**SUBJECT: NEW VEHICLE DEMONSTRATION / DELIVERY HOLD -
Compliance Recall 19C05**

Certain 2019 Model Year Fusion Energi Vehicles
High Voltage Wiring Electrical Shock Protection for Bus Electrical Center Fuses

**NEW VEHICLE DEMONSTRATION / DELIVERY HOLD -
Compliance Recall 19C05**

FIGURE 6

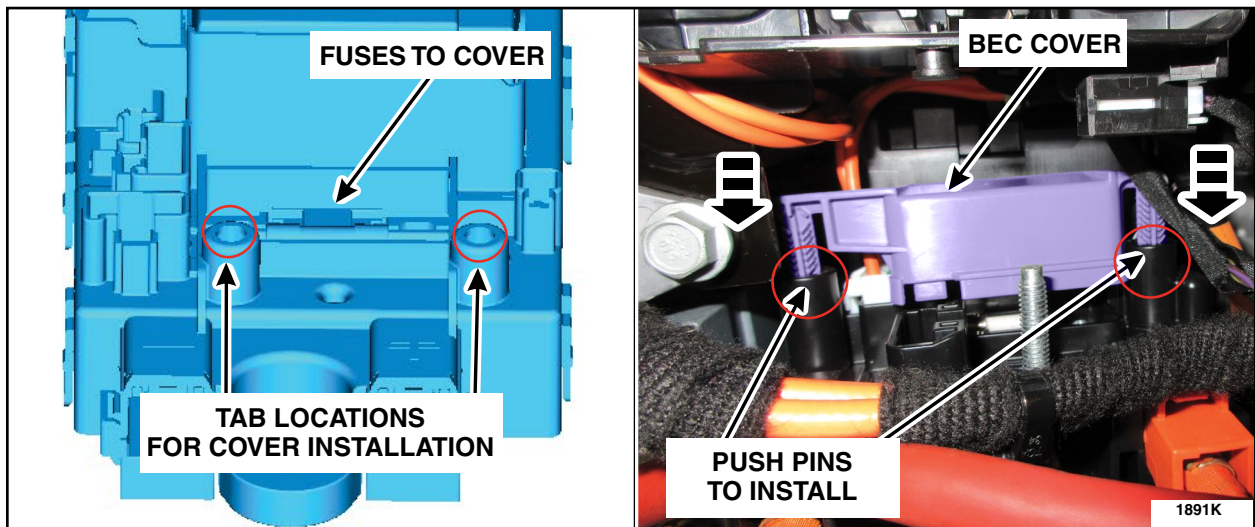
8. Install the BEC protective cover. See Figure 6.

NOTE: BEC protective cover is highlighted in purple for clarity in Figure 6. Actual cover is gray in color.
